**Re: QuikTrip 7001, Albuquerque**  
**Matkin Hoover Job No. 7001.01**  
**DFT PRJ # PR-2024-011229**

This letter and its attachments serve as a response to comments received on Dec 16<sup>th</sup>, 2024, concerning the above reference project.

# QUIKTRIP STORE #7001

SHEET TITLE:  
**LANDSCAPE PLAN**

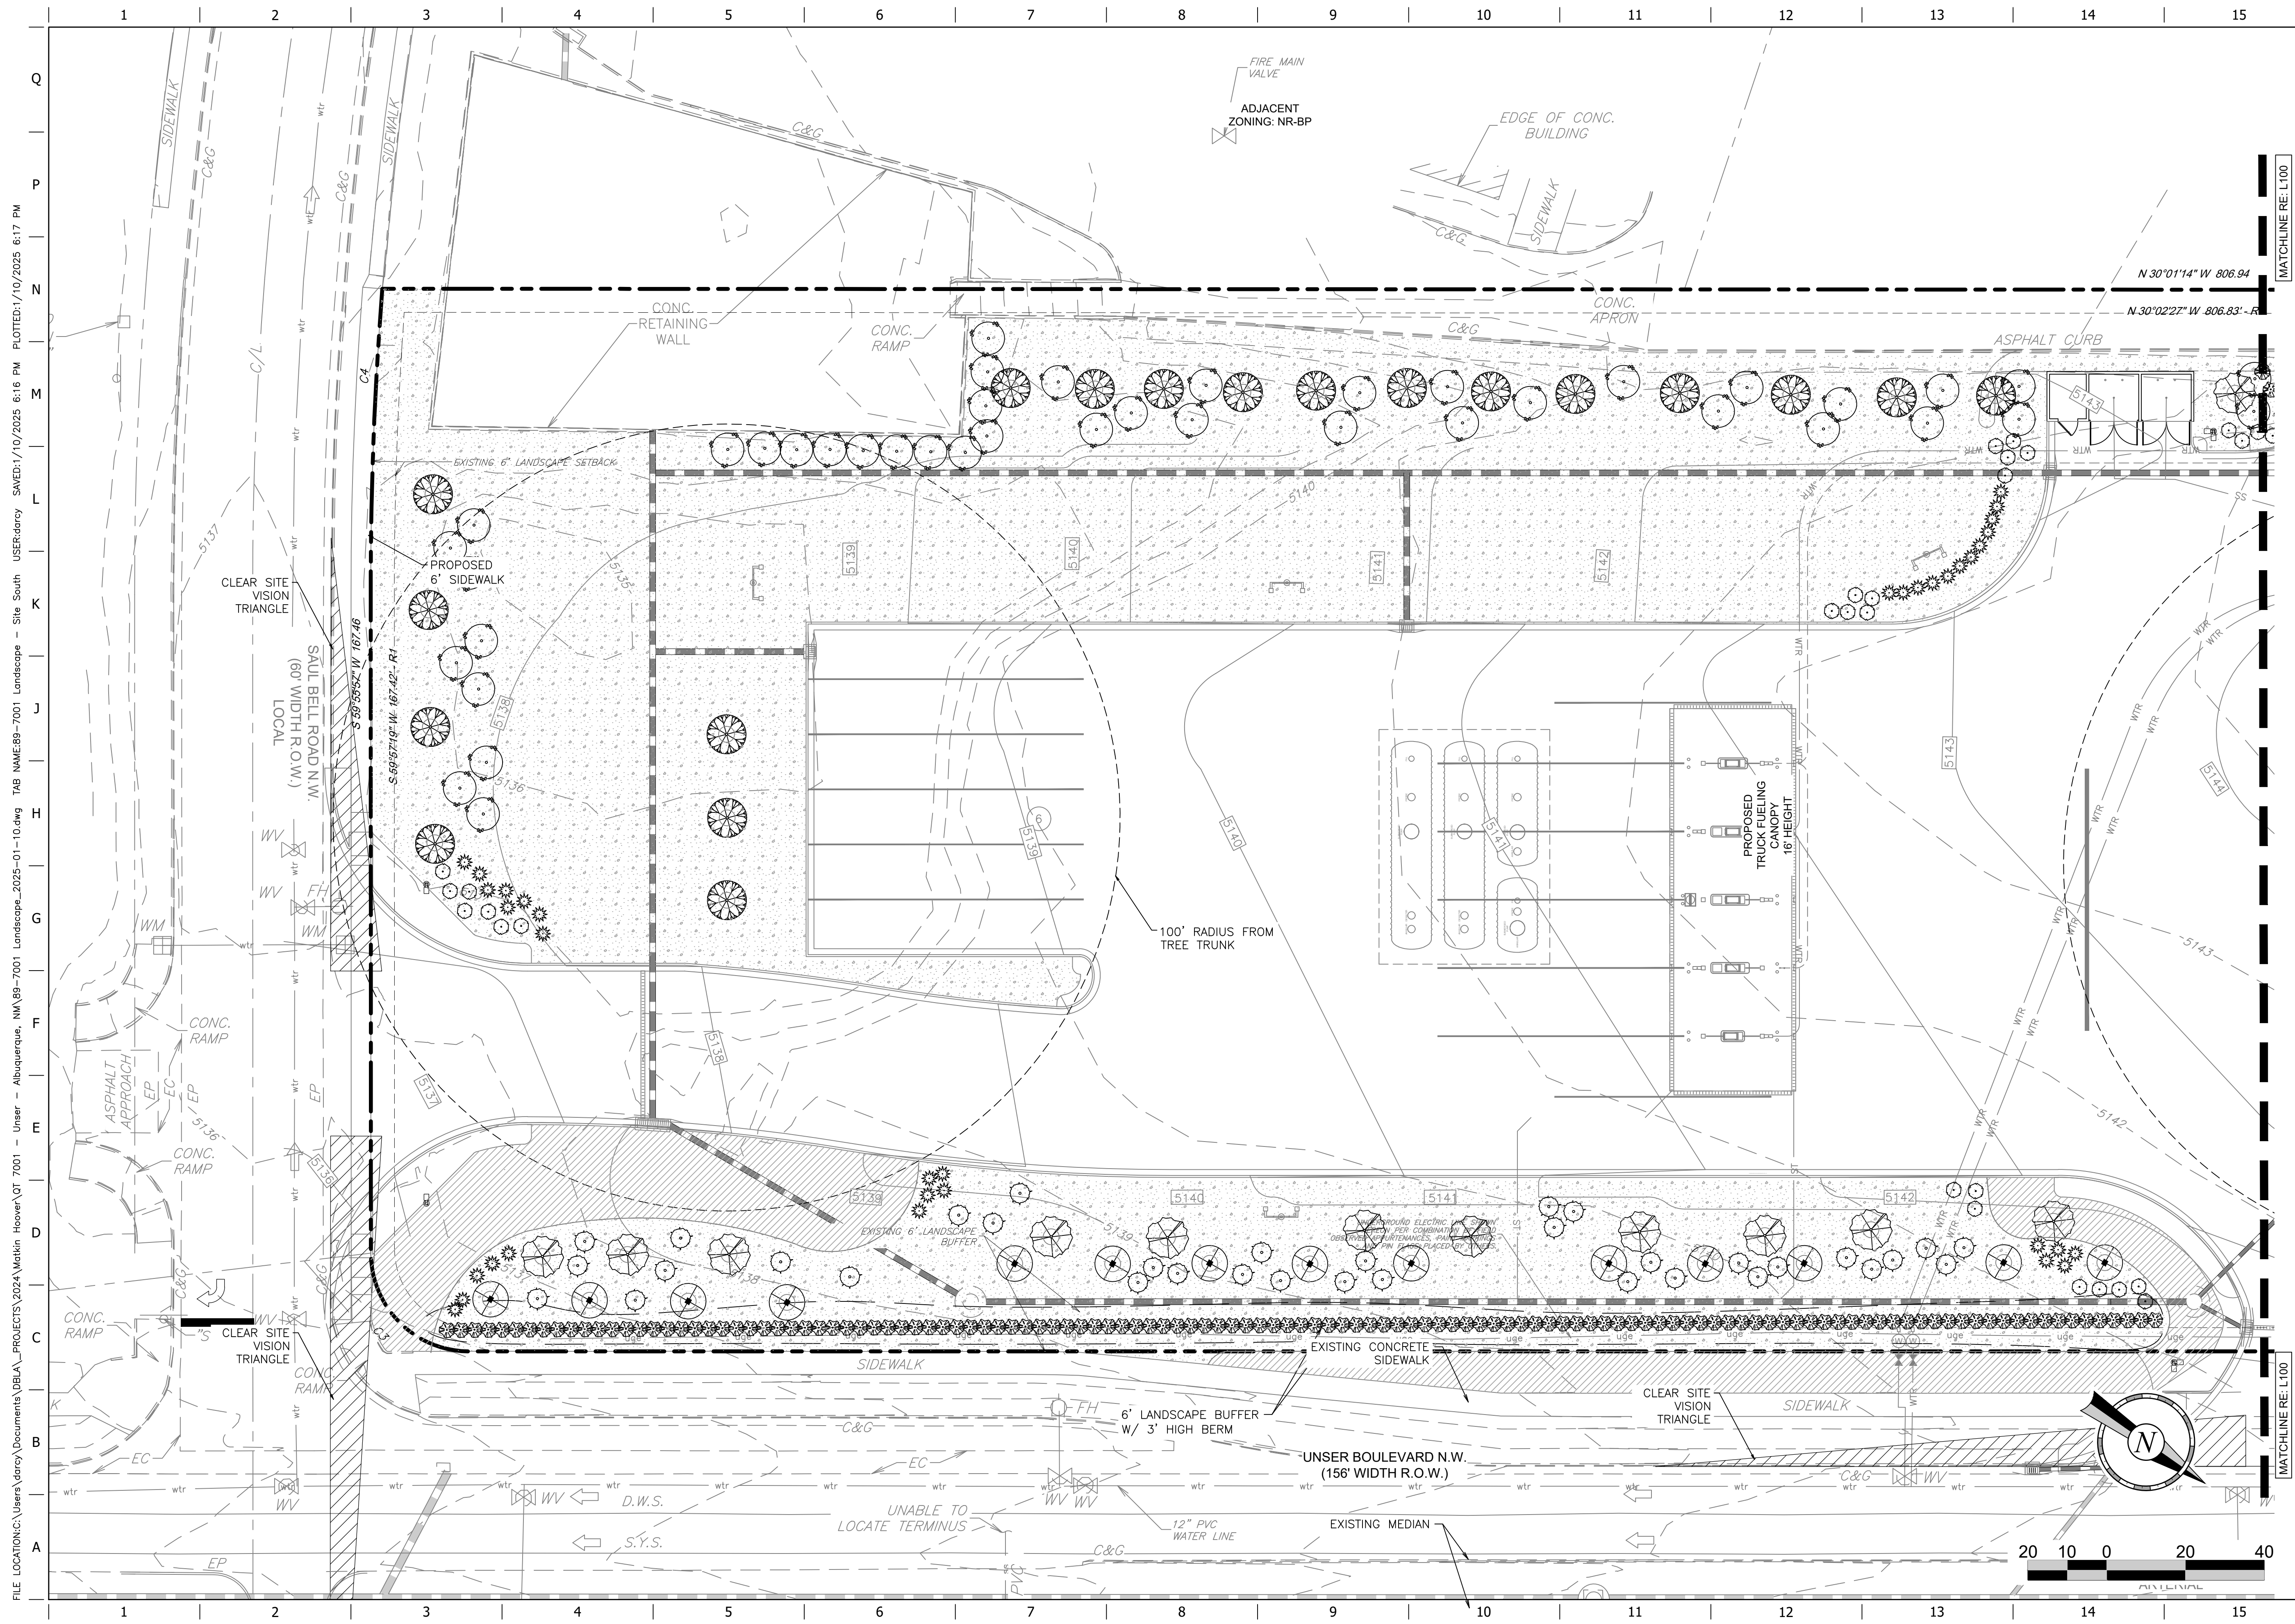
Landscaping, Parking, and Building Design must follow requirements of the Clifford Park West Business Park Master Plan, and where silent, the IDO requirements. Please review and correct if needed, adding notes showing how you are meeting those requirements

Landscaping does not appear to be following CWBP requirements: Please add notes showing how you are meeting the applicable specific requirements (ie: landscape for front setback and side setback areas, minimum 18% net site area, 75% living vegetative material, 20% turf, etc.).

Parking Areas: CWBP requires parking areas fronting on Unser are screened with “a combination of plant materials and earthen berming...with a minimum berm height of 3 feet.” Please show how you are meeting the specific parking area requirements of CWBP related to the landscape and berm.

Concur. Landscape Updated according to me requirements.

Concur. Landscape Updated according to me requirements.

Concur. Landscape Updated according to me requirements.

SHEET TITLE:  
 UTILITY PLAN NORTH

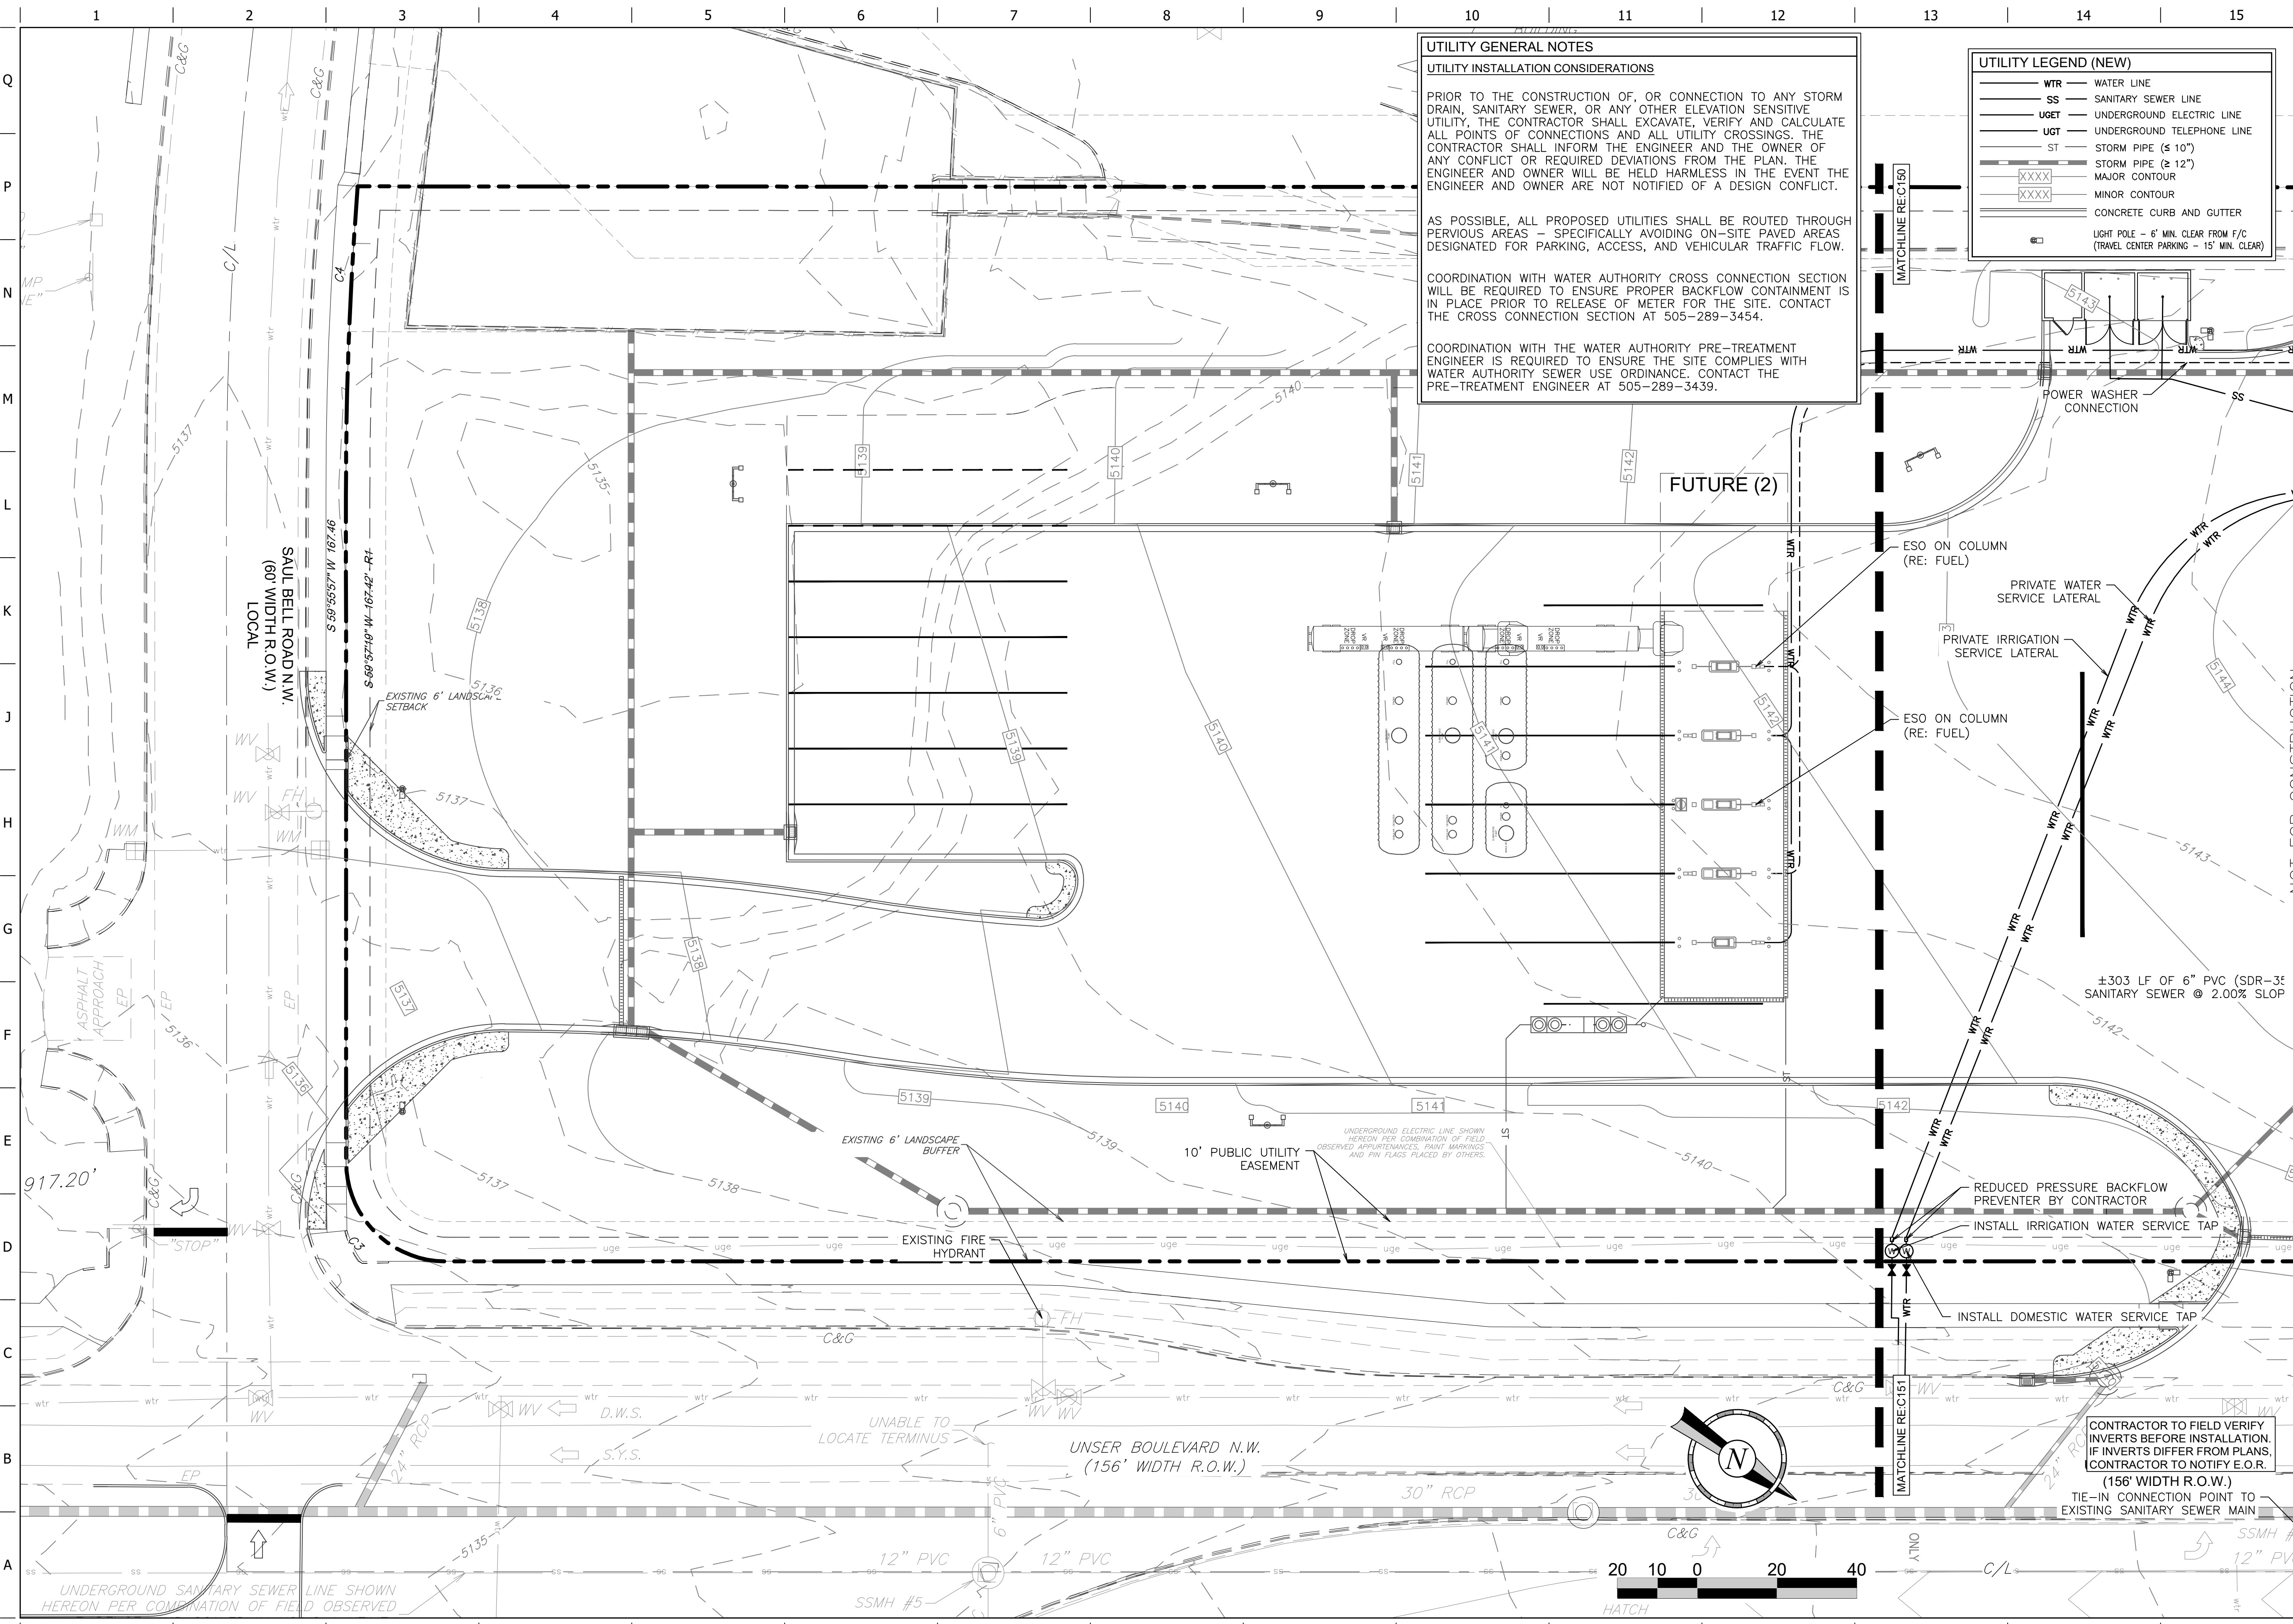
Dimension the public water and public sewer easements on the utility plan.

There shall be no trees, parallel fences/sidewalks/curbs, or structures within the public water and public sewer easement. Please revise accordingly.

Each service connection must have a separate connection perpendicular to the main domestic waterline. Manifolding of services is not permitted.

Please show the metered services within public right-of-way.

Concur. Utility Easement Callouts added to both north and south utility plans.

Concur. All trees, parallel fences, and structures removed from all related public water and public sewer easements onsite.

Concur. Service connections adjusted to be separate.

Concur. Meters adjusted as requested.
